SPD1000X Over Current Protection (OCP) function added in Firmware Revision 2.1.1.9

March 16, 2022

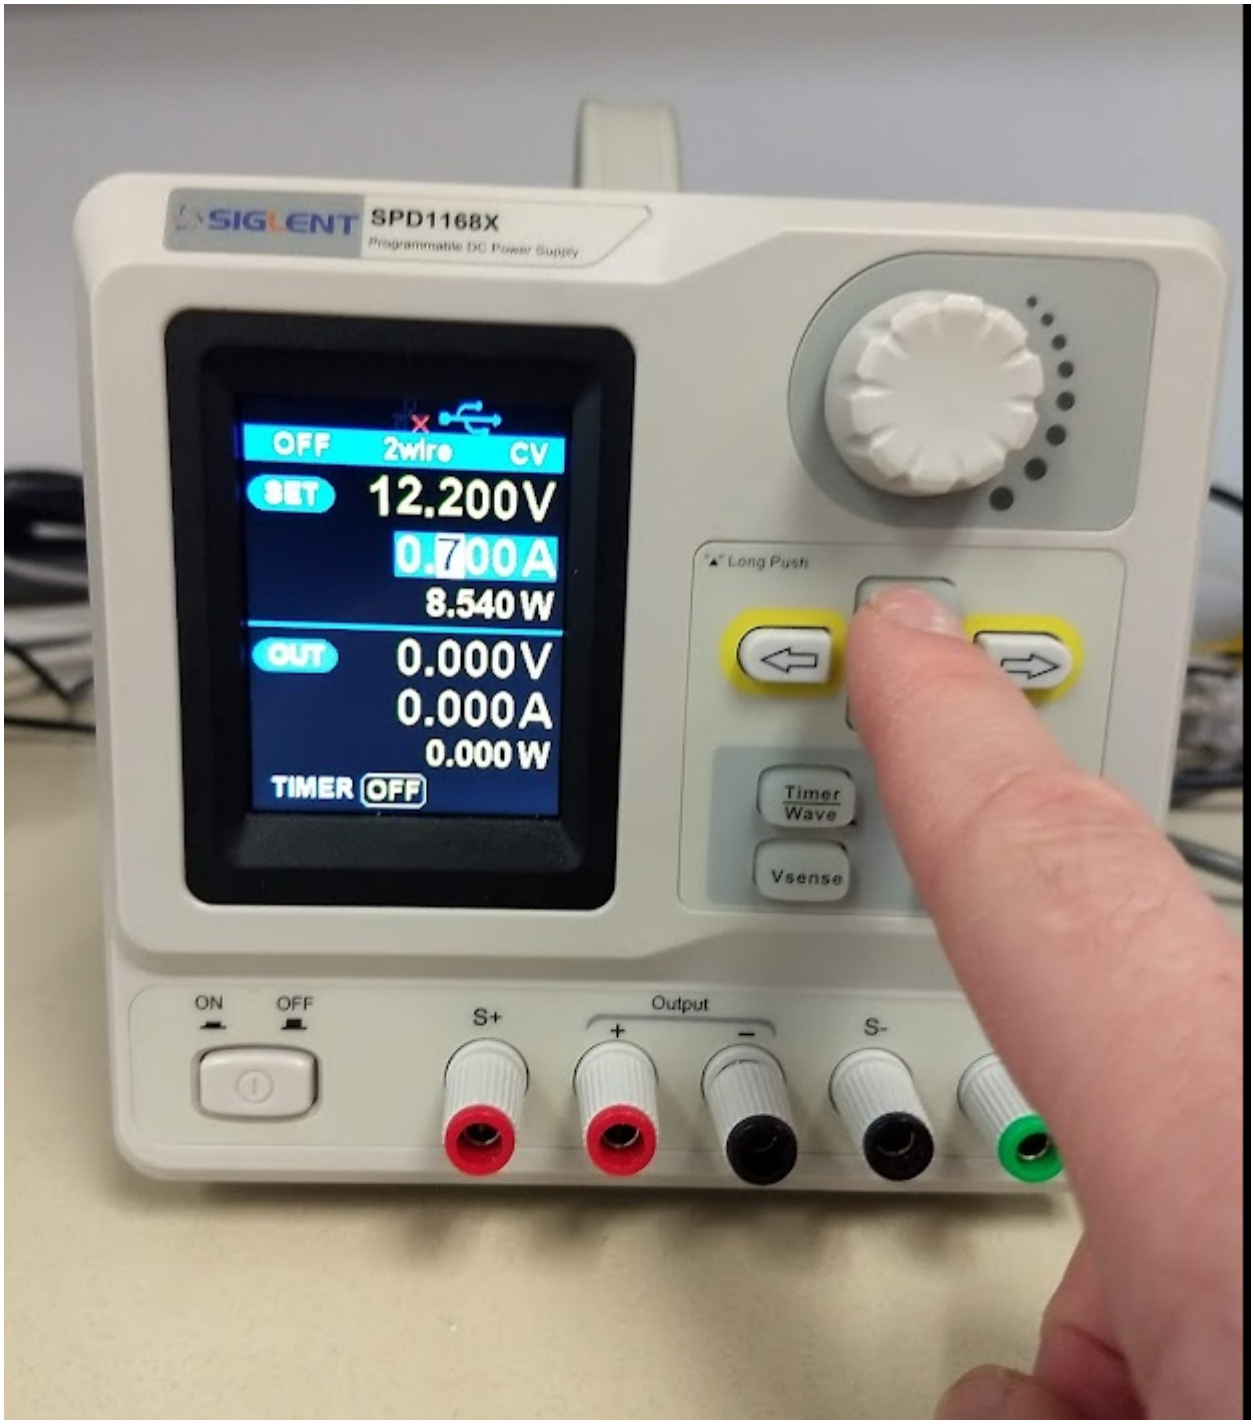
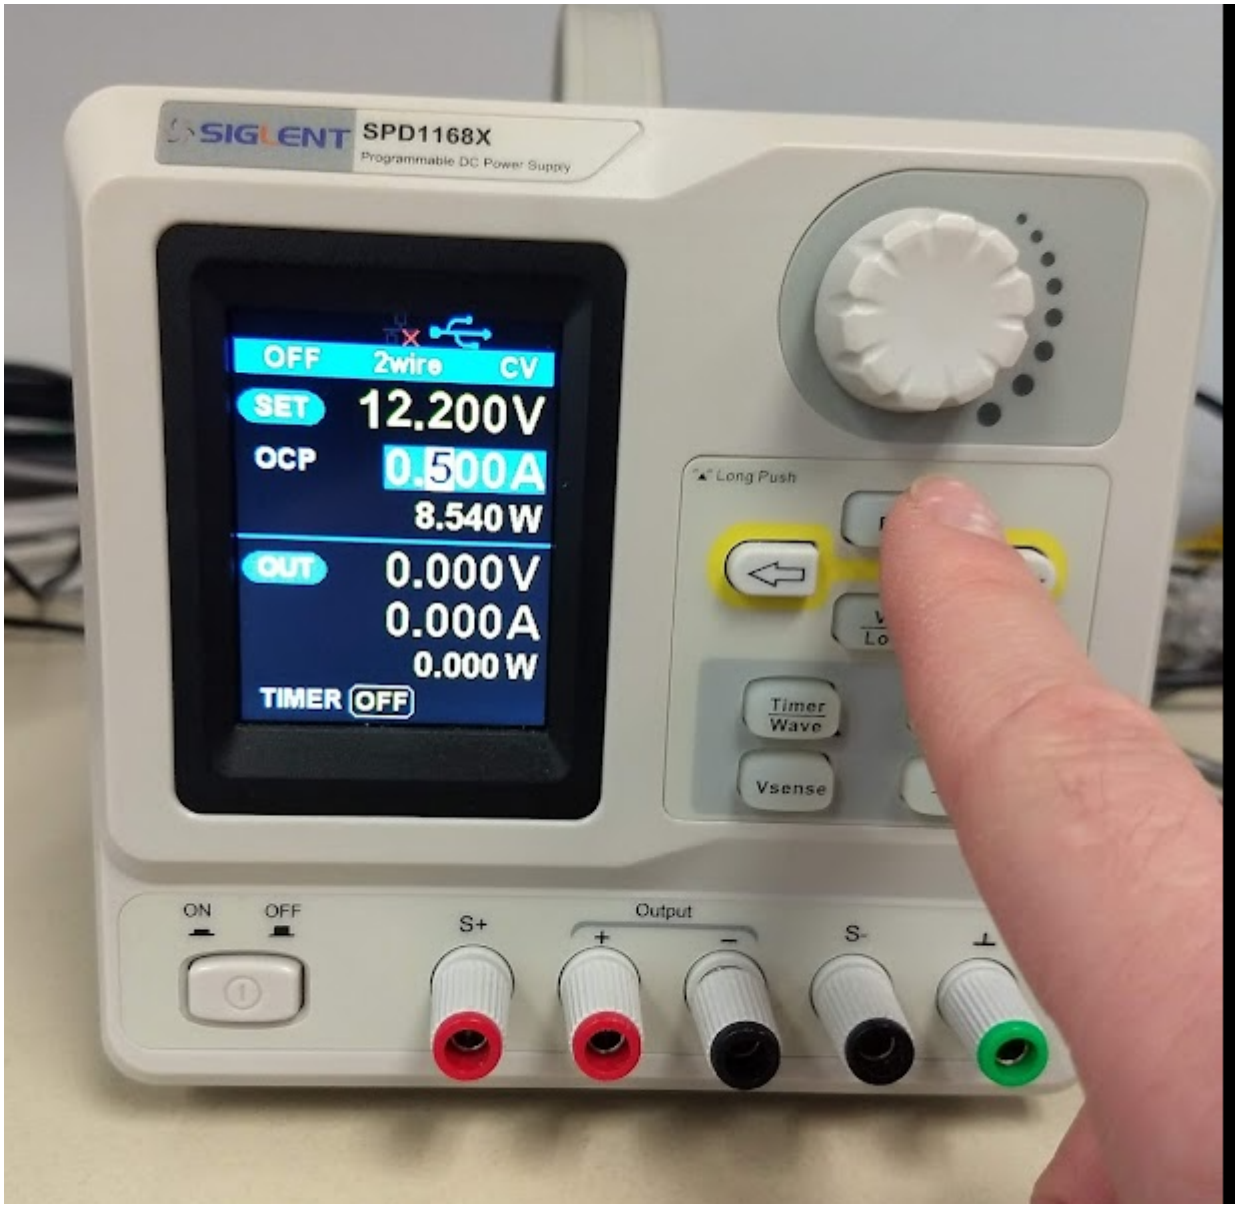
Over Current Protection (OCP) has been added to the SIGLENT SPD1000X series of single-channel power supplies with the SPD version 2.1.1.9

The OCP function quickly disables the output when the current draw from the supply surpasses the set limit current.

1. Update the firmware
2. Set the OCP value by pressing and holding the FINE button on the front panel. After a few seconds, the OCP label will appear:

3. Set the OCP current value using the knob and right/left arrows to adjust.

4. Long press the FINE button to remove the OCP menu selection.

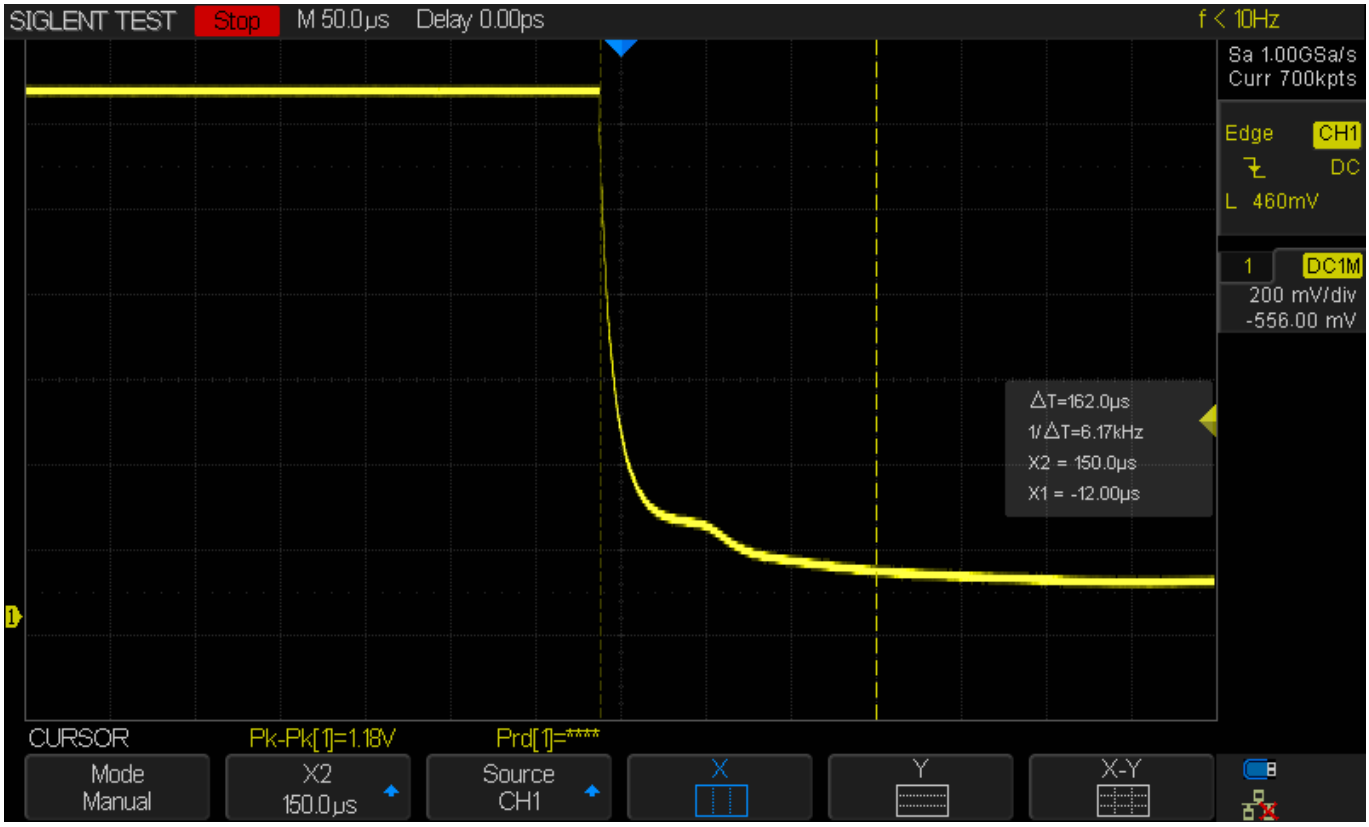
5. If the output exceeds the setpoint, the instrument will immediately disable the output and briefly show an error:

Here is an oscilloscope trace showing a shorted output causing an overcurrent situation (OCP triggered):
